RFI

RFI #: 217
Date: 1/3/2013
Job: EB-02 Keller Springs Lofts
Phone: 877-777-5115

Subject: Details needed for concrete pole base

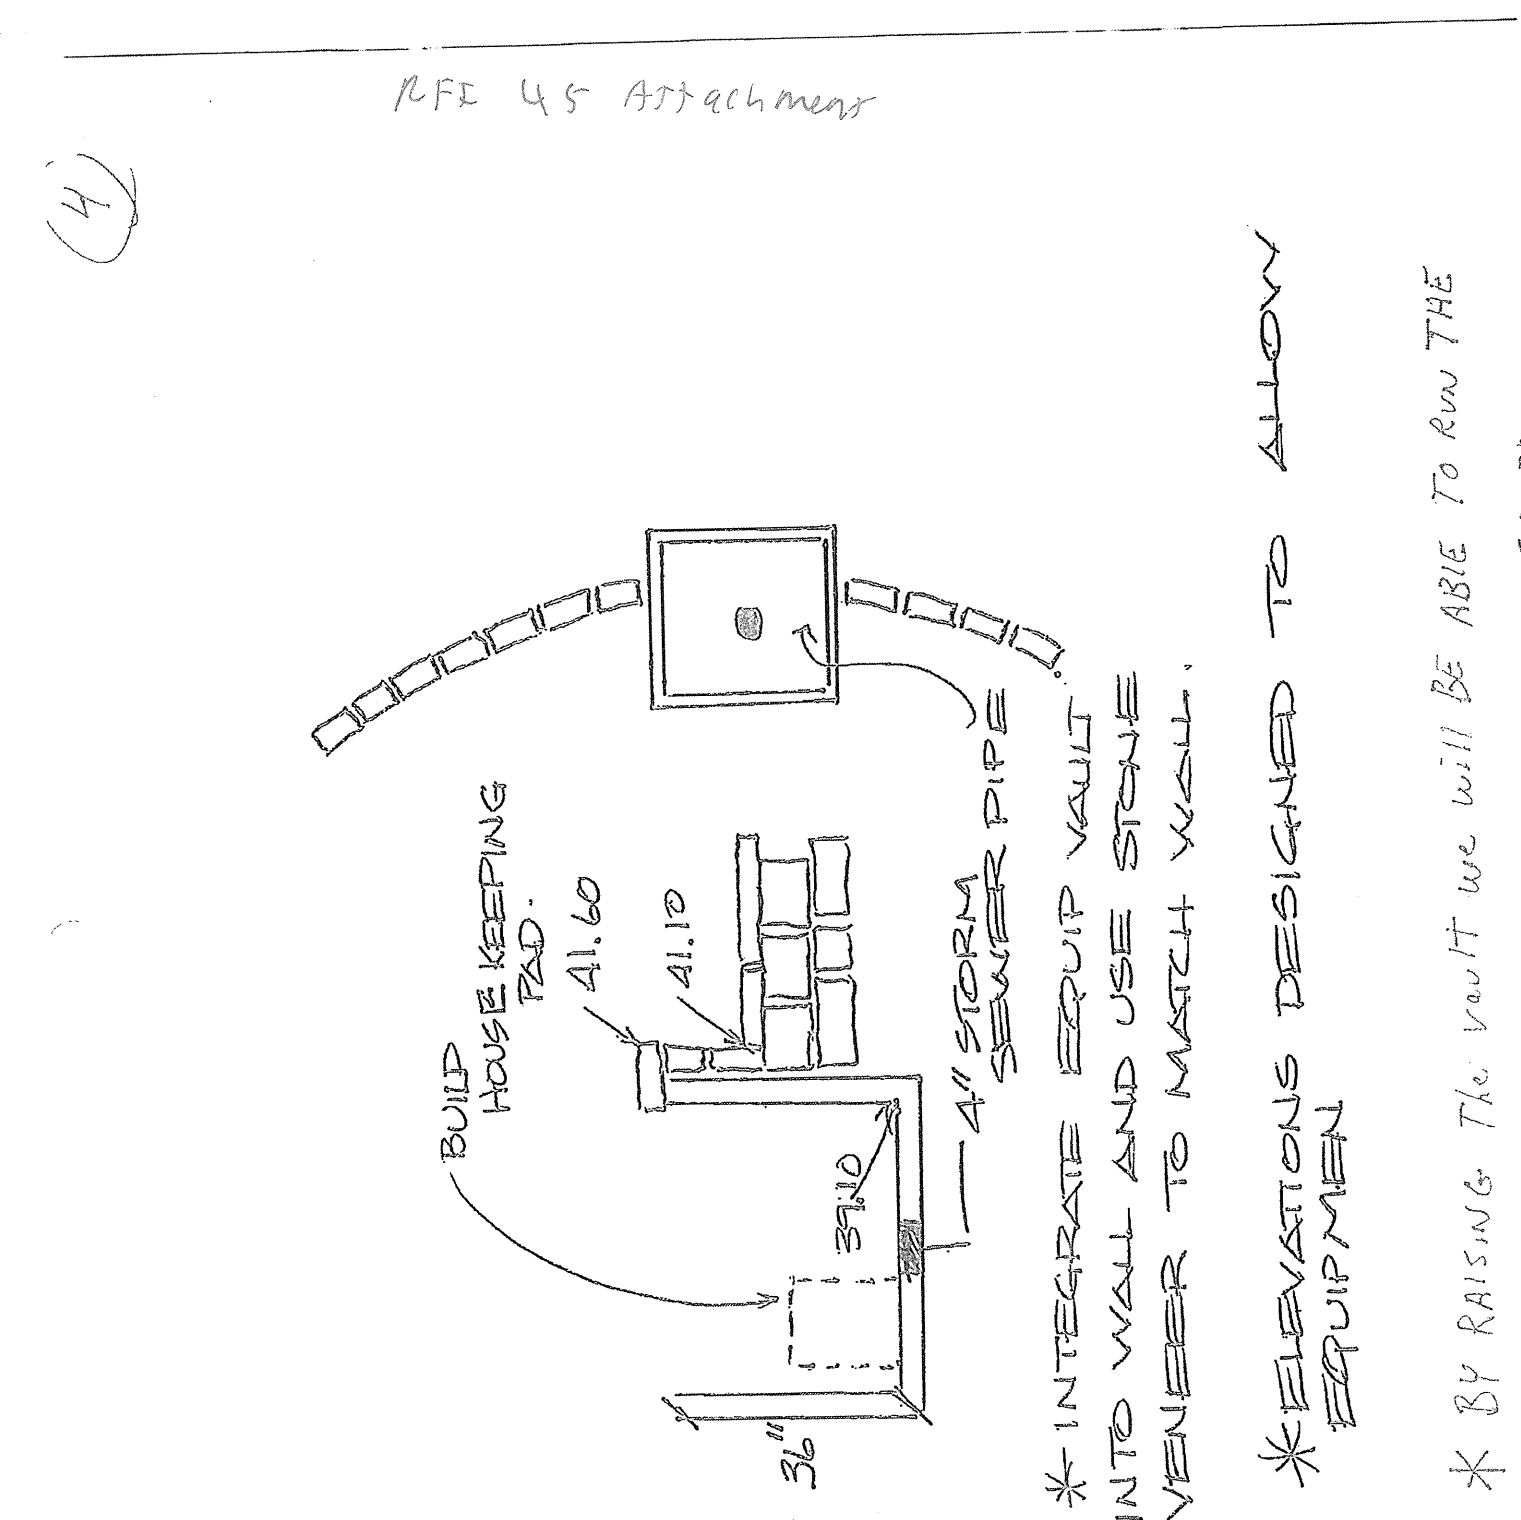
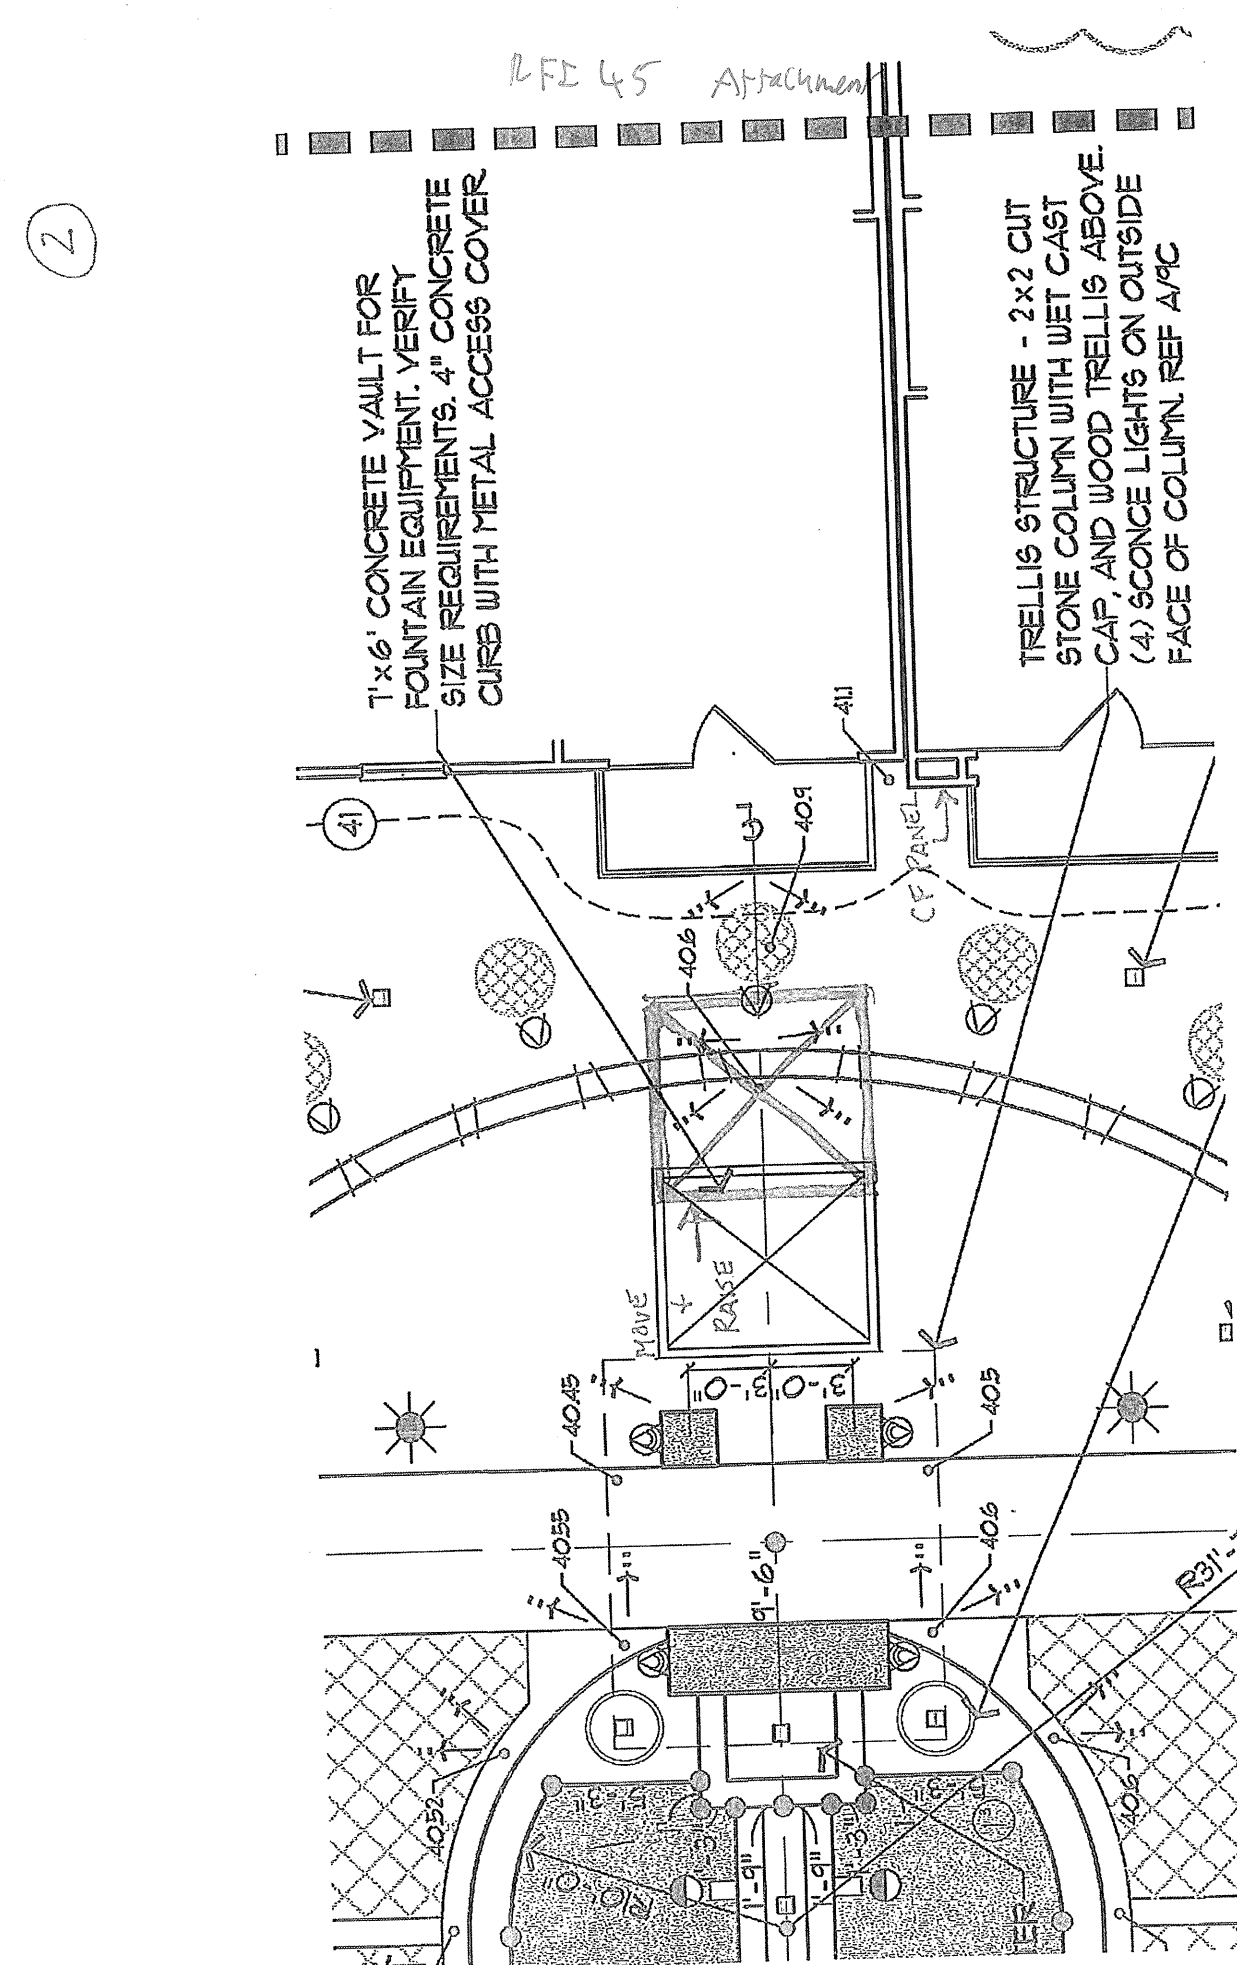
Request: Date Required: 1/24/2012
 On sheet E-1.3 on 12/21/11 a Panel 'CF' was added to the panel as a design revision. Is this for the fountain courtyard including the fountain equipment?

Sheet E-1.7 Panelboard schedule 'CF' has a note for contractor to coordinate with landscape and architect on location of 'CF' Panel. In talking with my electrician and pool contractor, we all feel the location for the CF panel should be located at the pop-out area in building between the patio's located to the southeast of the fountain equipment vault, which would be about 14' away from the power. By locating this panel in the courtyard, it would make any future changes or additions for the power requirements to the courtyard readily available.

Response: We are fine with the proposed location of the electric panel. We do have a proposed Japanese Yew that will be in conflict with the panel, so we recommend not installing the Japanese Yew and just filling the area in with Liriope groundcover.
